1. INTRODUCTION

1.1 NON MATERIAL AMENDMENTS APPLICATION

This Design and Access Statement has been prepared by Simpson Haugh Architects with input from others on behalf of Forshaw Land and Property Group (The Applicant). The document accompanies a Section 96A TCPA 1990 application for Non Material Amendments to the consented application (ref: 122000/FO/2018) for the Victoria House site.

Proposed North-East Elevation

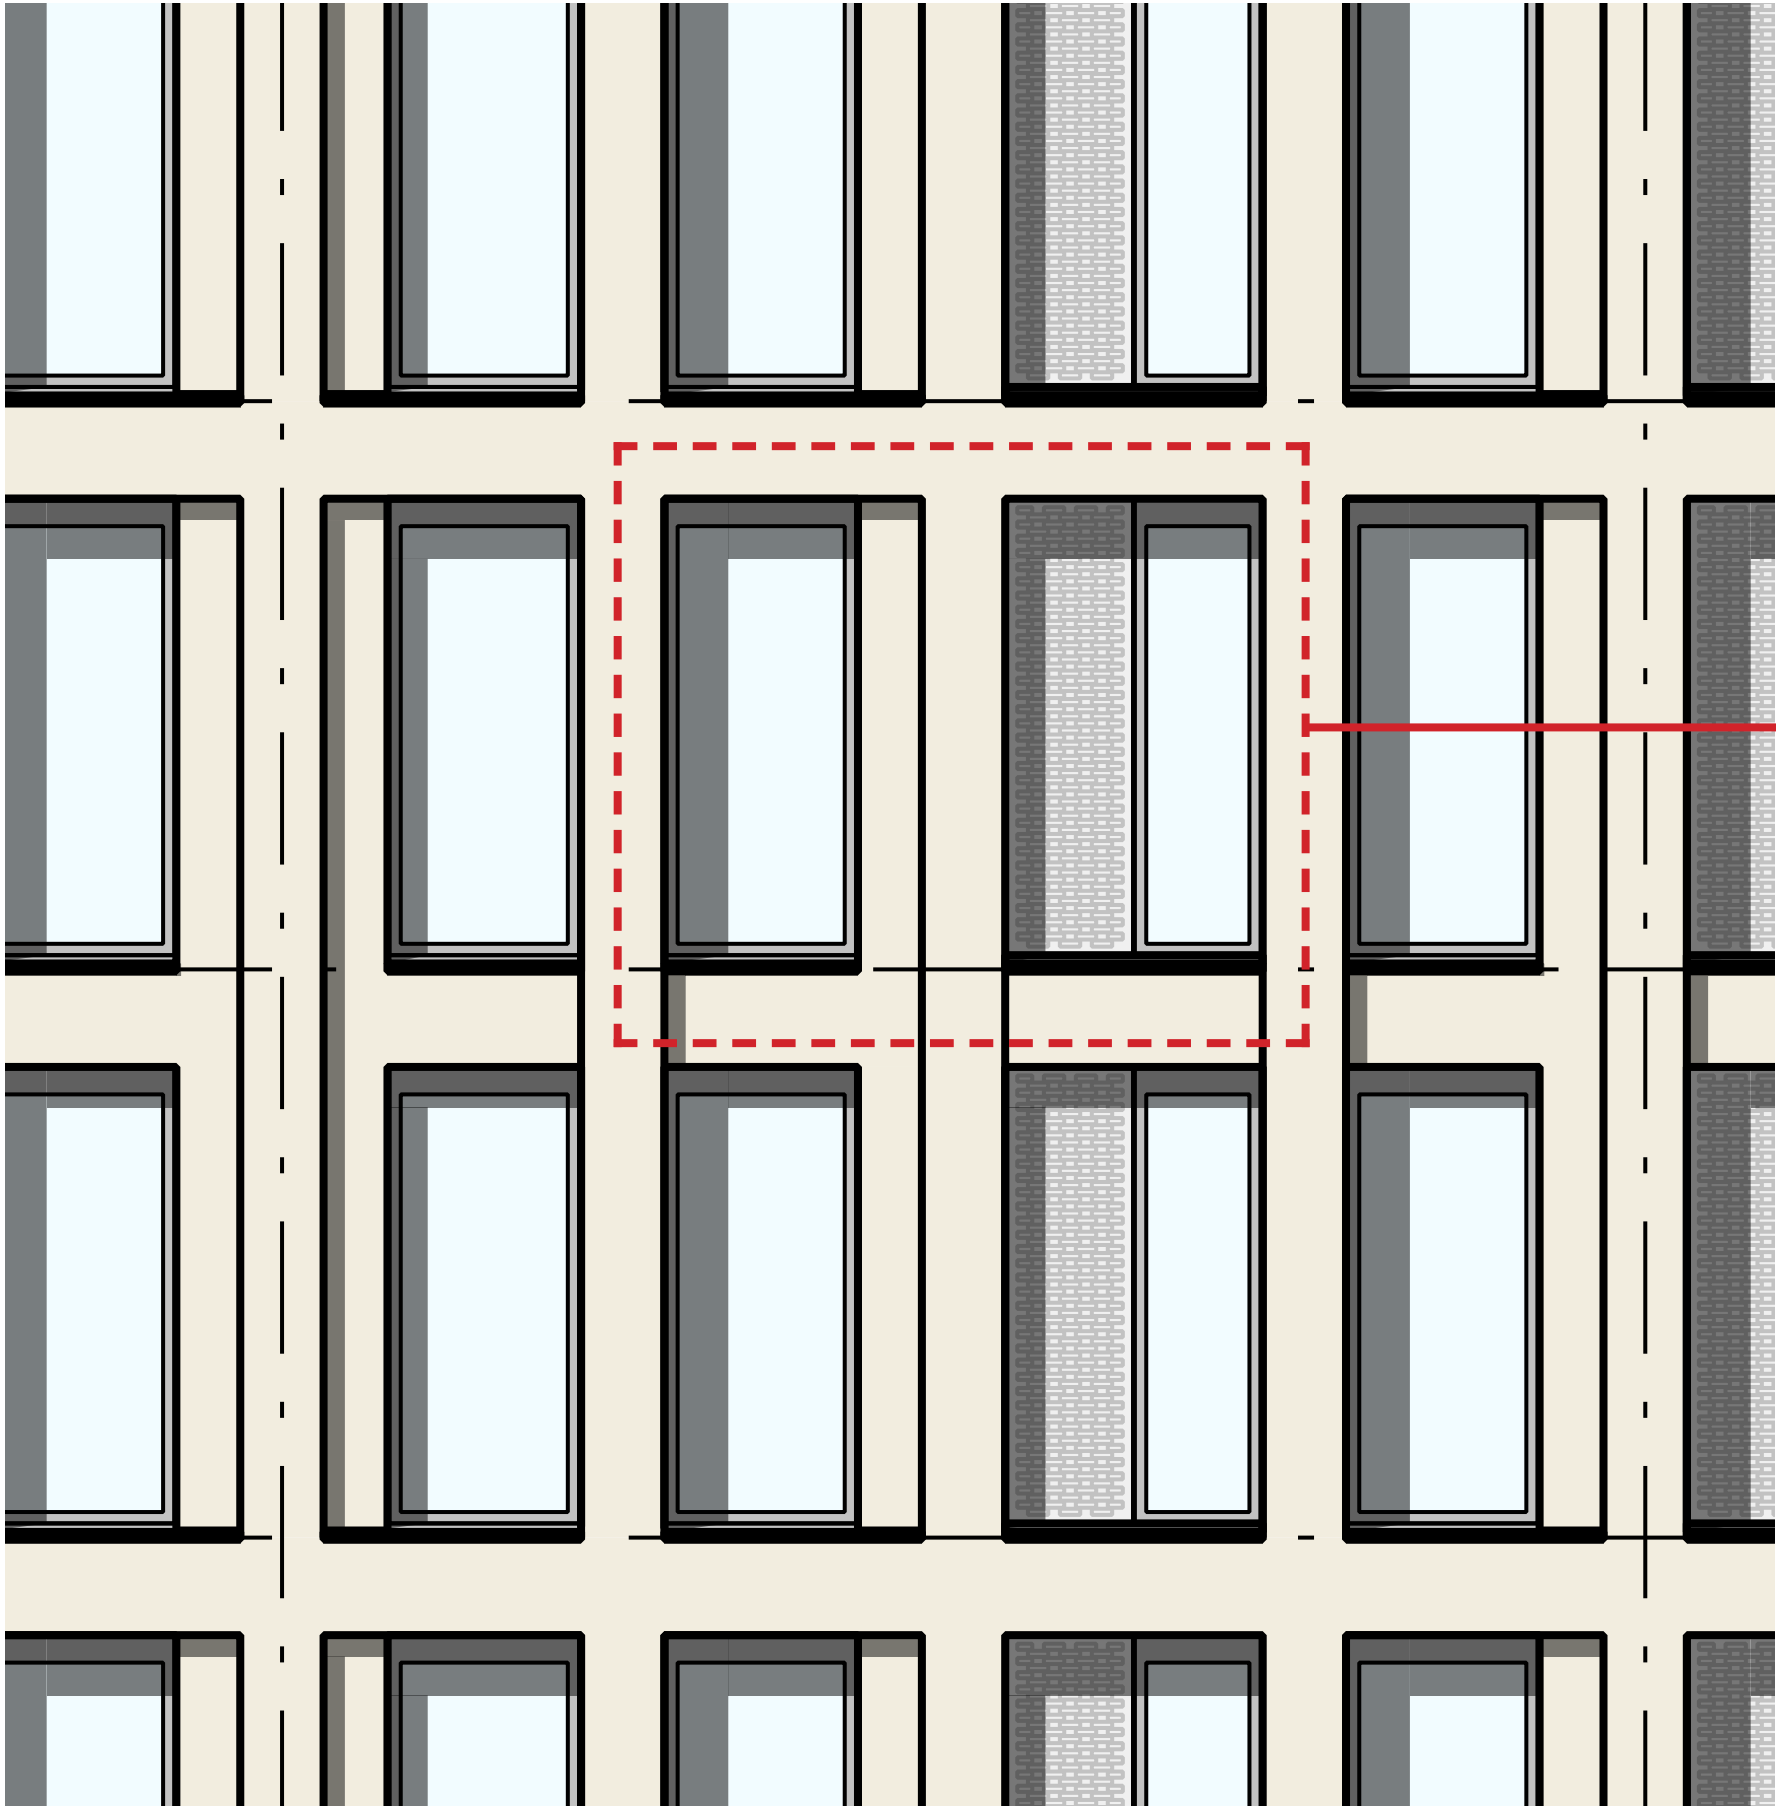
The consented scheme proposed rapid vents designed as flush finished perforated metal screens concealing a pivoting solid ventilator. The rapid vent detail has been developed to have a flush finished perforated metal screen concealing a pivoting fully glazed ventilator. This change will enhance the original design to achieve a visually lighter appearance. It also maximises the extensive views from apartments and increases natural daylight into living spaces.

With the increase in area of glazing, SAP Overheating Assessments have been carried out to ensure that all apartments comply with Part L of the Building Regulations.

Consented Wind Baffles - South West Elevation

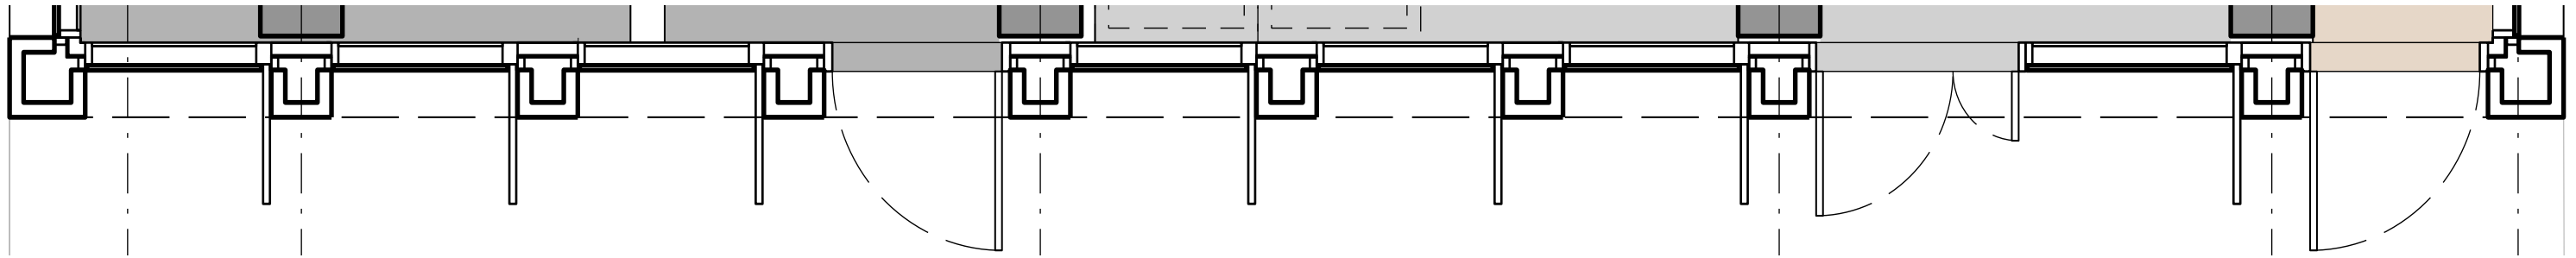
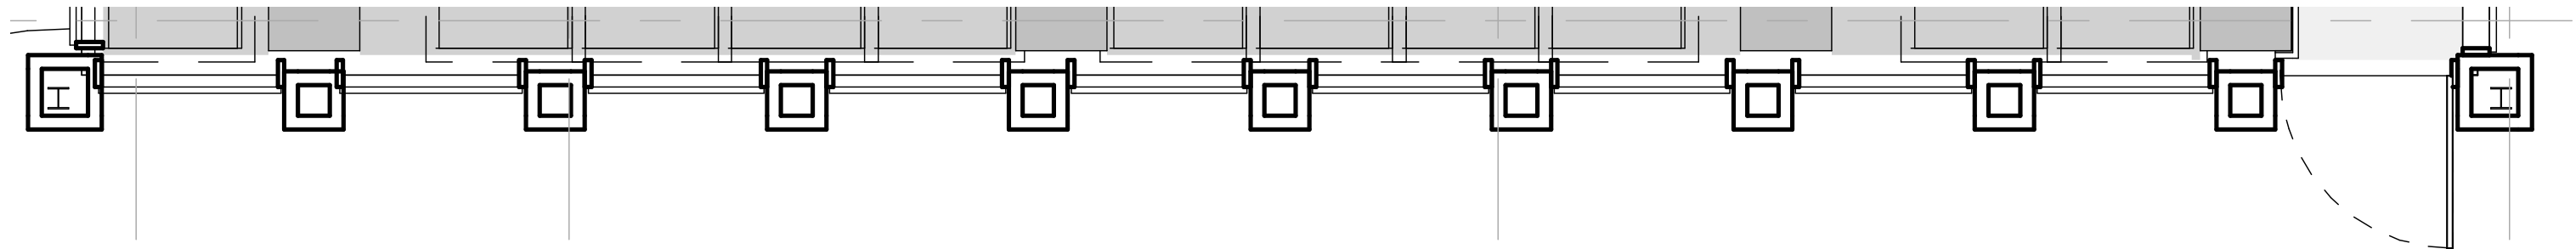
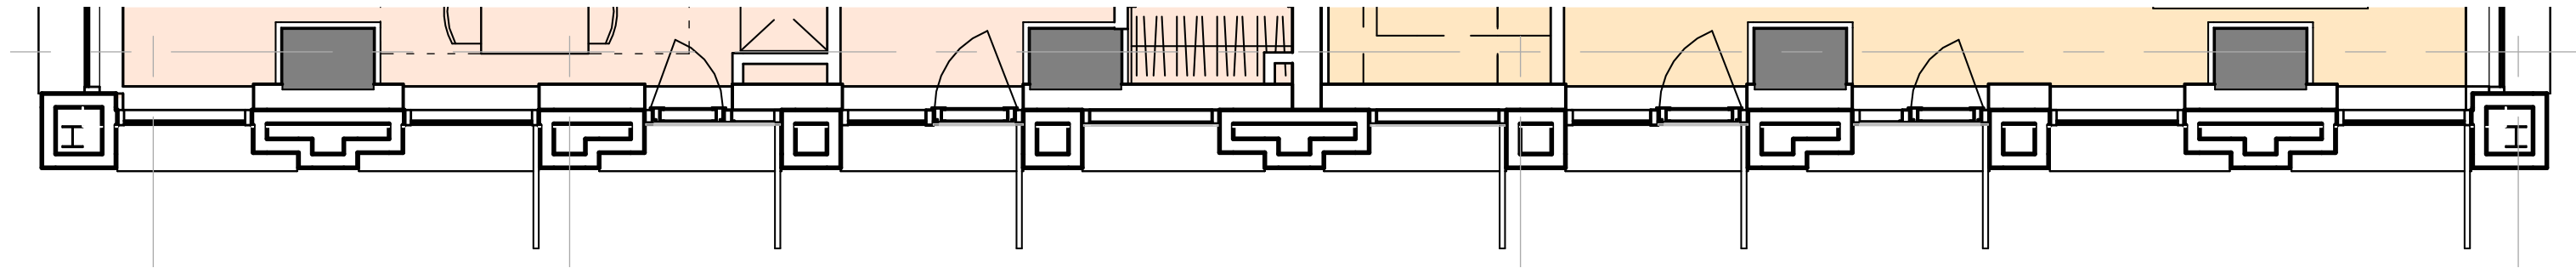
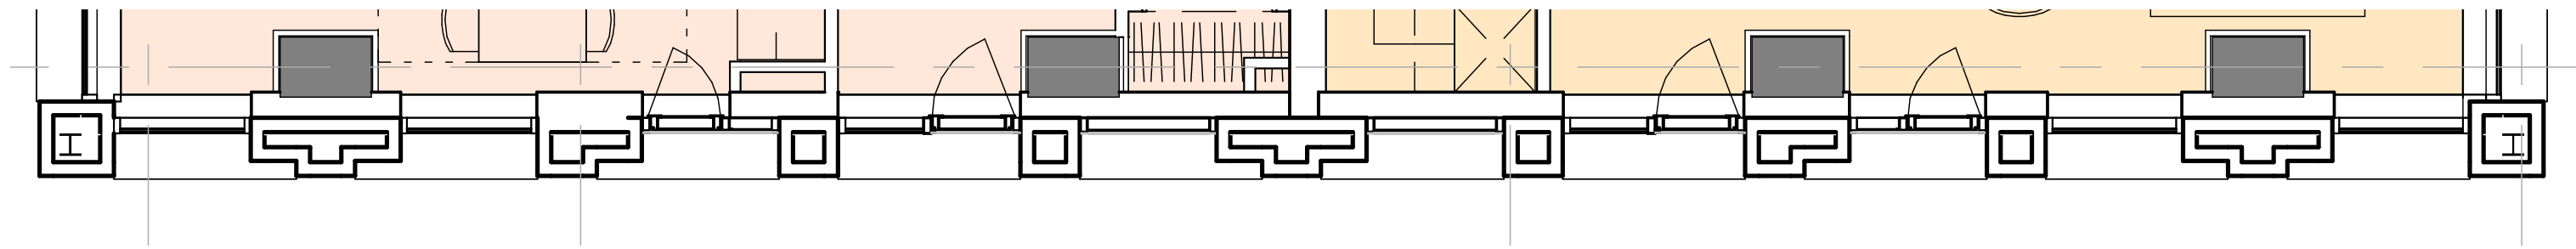
The consented scheme includes wind baffles on the south west elevation as part of the wind mitigation strategy.

The construction of the adjacent Heyrod Street scheme provides shelter to the Victoria House building from the south west wind direction so an updated wind mitigation assessment was undertaken which concludes that with the neighbouring Heyrod Street scheme the wind safety exceedance is eradicated and comfort conditions are suitable for the intended use. Therefore the external perforated fins and trees are no longer required to achieve suitable conditions. The decision was then made to omit the external perforated fins.

Consented North-East Elevation

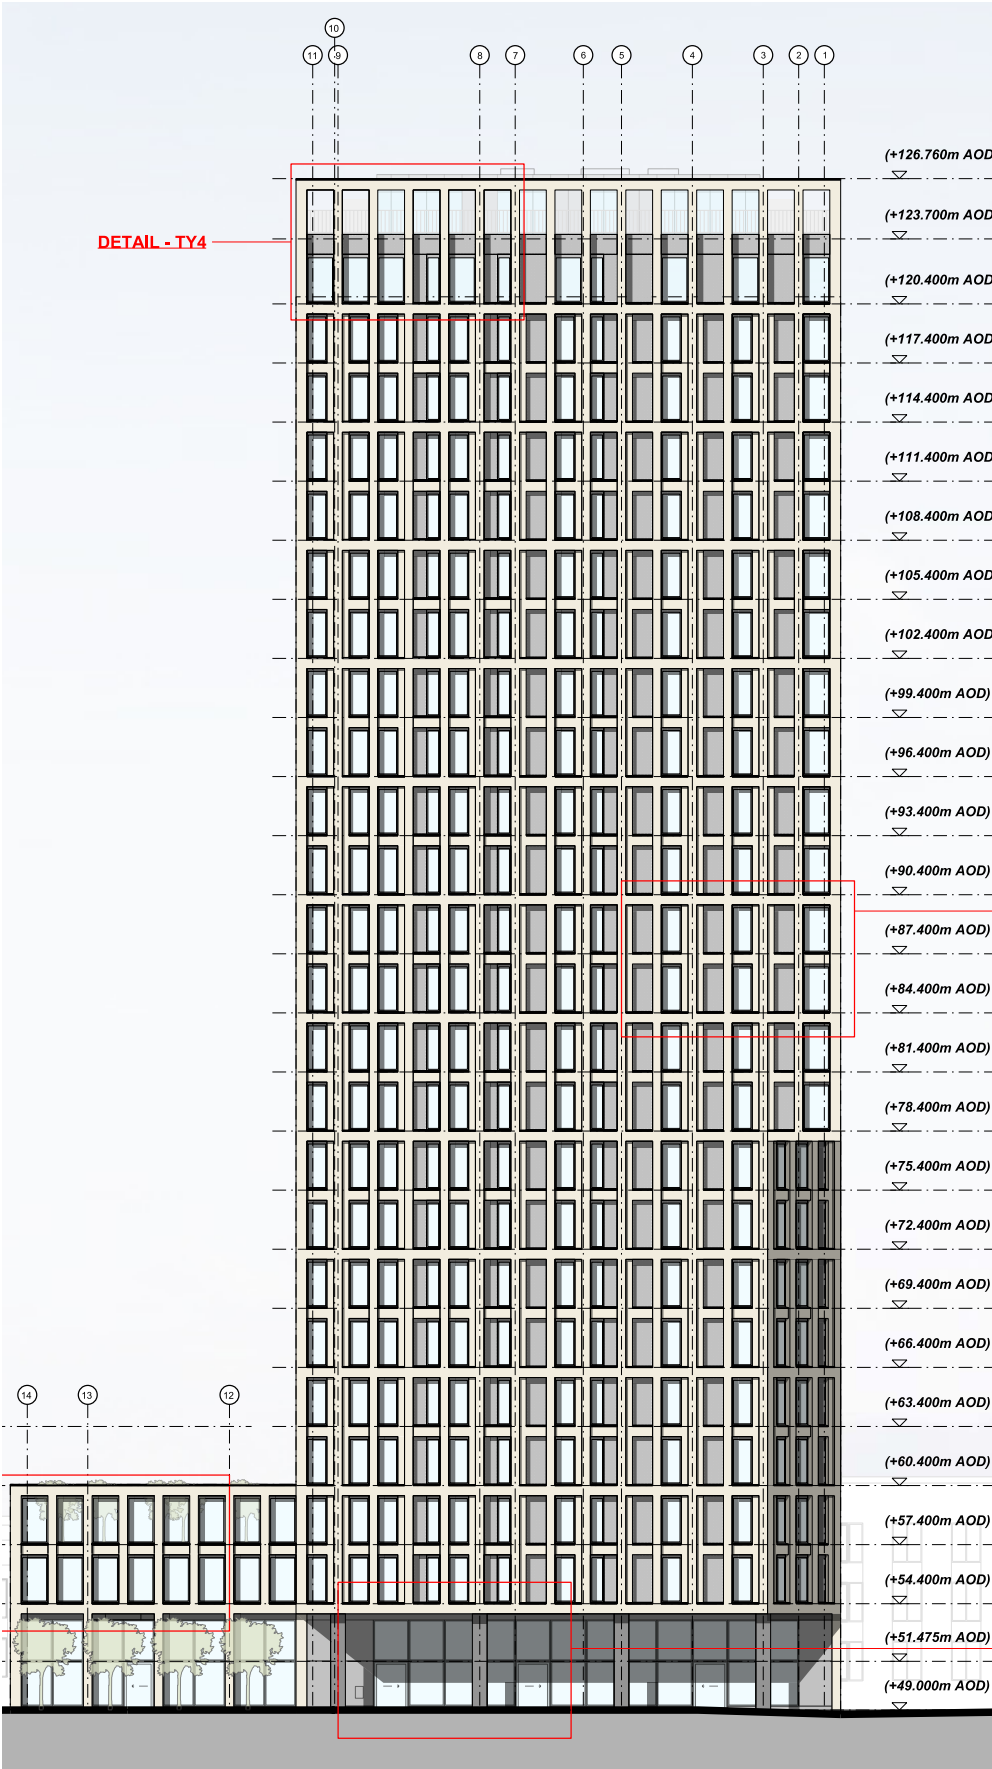
Following technical design development of the curtain wall system, the proposed elevations indicate additional horizontal transom details to the ground floor sliding doors, which is required to provide additional structural support.

Proposed minor window type amendments on the proposed North East Elevation are highlighted in dashed red lines. This window type has been changed from clear glazing to fritted glazing to provide privacy to an apartment ensuite that repeats from level 03 to 22.

Consented North-West Elevation

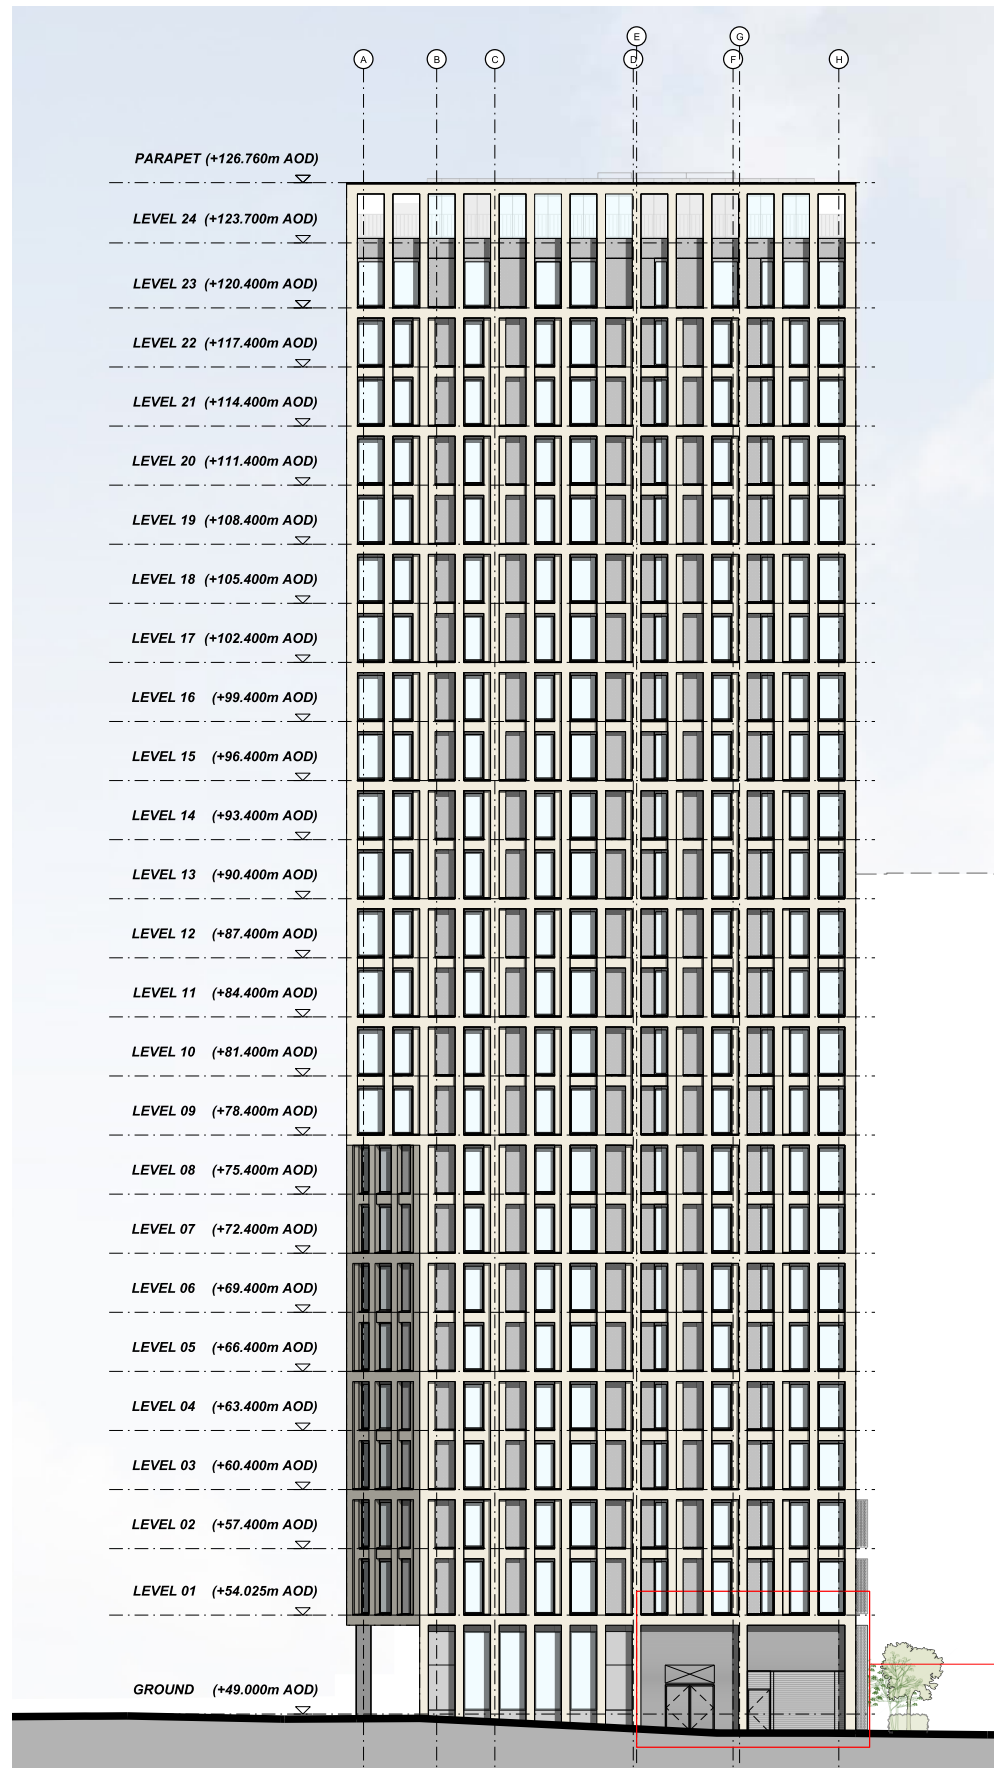
The North West ground floor elevation is a mix of clear glazed and solid aluminium curtain wall panels. Due to the reconfiguration of the back of house spaces (refuse store, substation and switchroom), a clear glazed panel is proposed to change to a solid aluminium panel. The louvred curtain wall to the substation, cycle and refuse store has been reconfigured so that the transom aligns with the additional Mezzanine level, as well as a set of double doors at ground floor for external refuse access.
